Building R4A Barangaroo South Modification 3

State Significant Development Modification Assessment
(SSD 6964 MOD 3)

February 2021

Figure 7 | Amendments to winter garden glazing at levels 68 and 69 (Base source: Applicant's Design Report)

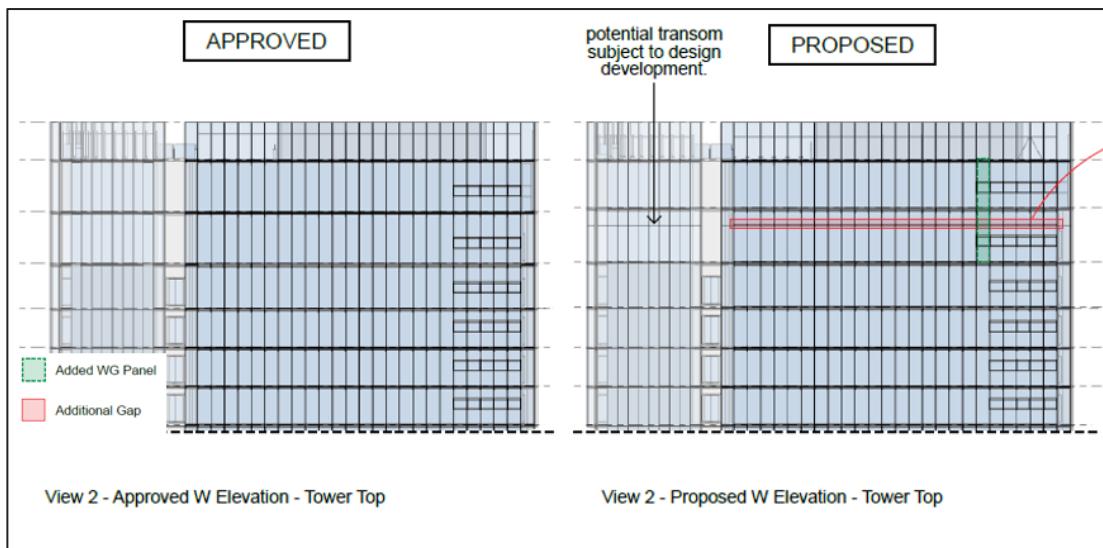
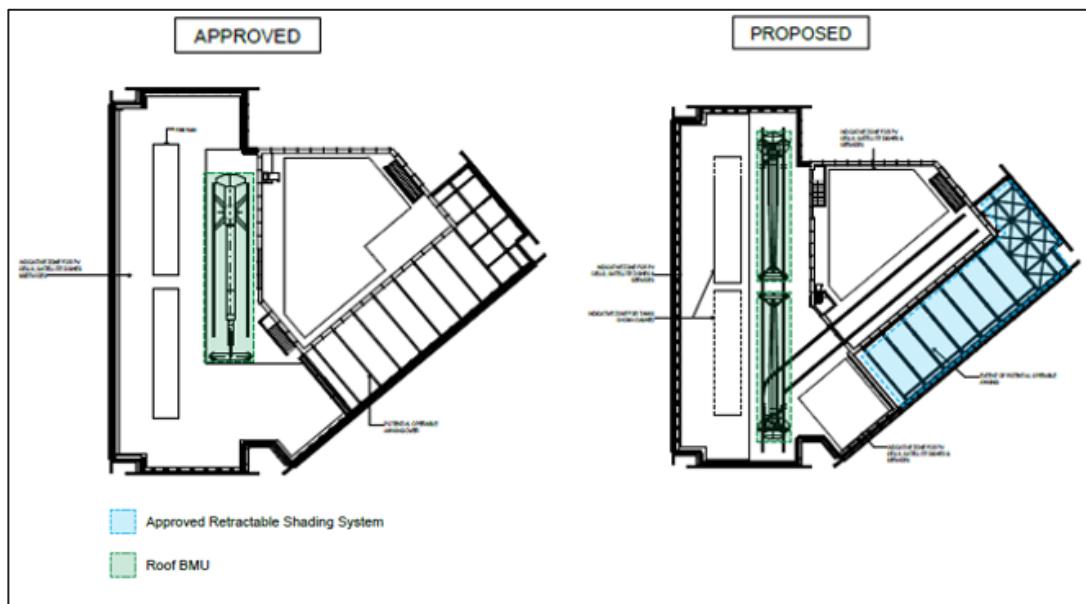
Design Excellence	<ul style="list-style-type: none">• The proposal seeks approval for external alterations to the façade as outlined in Table 2 and shown in Figures 7 and 8.• The Applicant's design verification statement confirms the design integrity of the original project is maintained.• The Department has considered the proposed external façade changes and is satisfied that the building will continue to exhibit design excellence as:<ul style="list-style-type: none">◦ the proposed materials and finishes are consistent with the existing approval◦ the amendments to the wintergarden glazing panels are required to address internal changes and will not disrupt the external rhythm of the façade	The Department recommends the list of drawings be updated to reflect the changes.

<ul style="list-style-type: none"> ○ the introduction of opaque glazing will serve to screen the internal pool structure and will appear consistent with the adjacent glazed panels ○ the proposed transom (Figures 8 and 9) will ensure the horizontal rhythm of the façade is retained ○ the amendments to the BMU and retractable roof awning would not be visible from the public realm and will not affect the appearance of the building ○ the amendments would not alter the bulk, scale or height of the building and would maintain the architectural design integrity of the façade. ● The Department's assessment therefore concludes the proposed external alterations would have a minor impact on the appearance of the building and would not diminish or detract from the design excellence of the approved building. Further, the Department is satisfied the proposal would not result in any significant visual or amenity impacts beyond those already assessed and approved.

Figure 10 | Alternative signage zone for building address signage on the north west elevation at ground floor level fronting Barangaroo Avenue (Base source: Applicant's Design report)

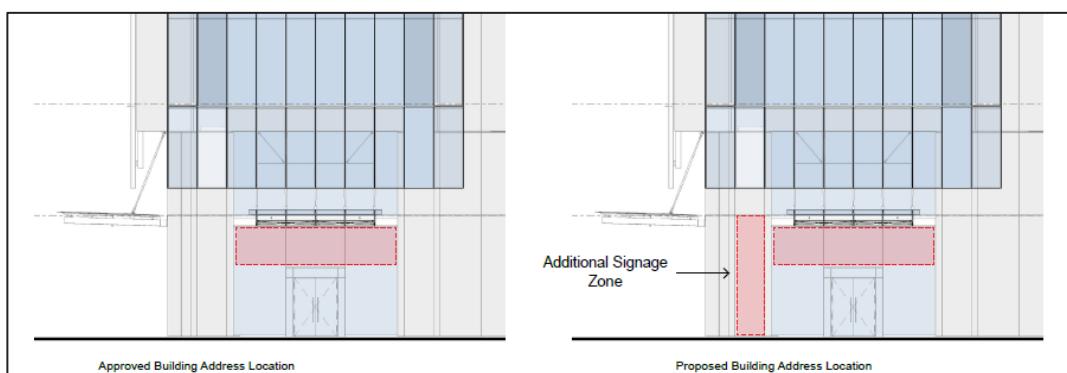
Signage zones	<ul style="list-style-type: none"> ● In addition to the approved signage zone located on the ground floor north west entrance elevation fronting Barangaroo Avenue, the proposal includes an additional, alternate signage zone measuring approximately 5 m x 1 m (5 m²) (Figure 10). ● The Department notes that Control 9 in the Concept Plan Design Controls stipulates signage is to be limited to one sign per frontage at podium level and is not to exceed 15m² per sign. 	<p>The Department recommends a new condition limiting the location of future signage to within only one of the</p>

<ul style="list-style-type: none"> • The Applicant stated that the second signage zone is sought to provide flexibility for the location of a future single sign and not to allow for two signs. • The Department considers the proposed alternative signage zone is acceptable and meets the key criteria in SEPP 64 (Appendix C) and will provide flexibility for potential signage locations in future DA(s). However, to ensure consistency with the concept approval the Department recommends a new condition restricting future signage to be located within only one of the two approved signage zones. 	two approved signage zones.
Accessibility	<ul style="list-style-type: none"> • The modification is supported by an Accessibility Review, prepared by Morris-Goding Accessibility Consulting, dated 5 November 2020. • The reports confirm that the modification is capable of complying with the provisions of the BCA, Disability (Access to Premises) Standards 2010 and relevant Australian Standards. • The Department accepts the findings of the Accessibility Review and notes Existing Condition B34 requires access for people with disabilities to be designed in accordance with the BCA. 	No changes to conditions recommended.
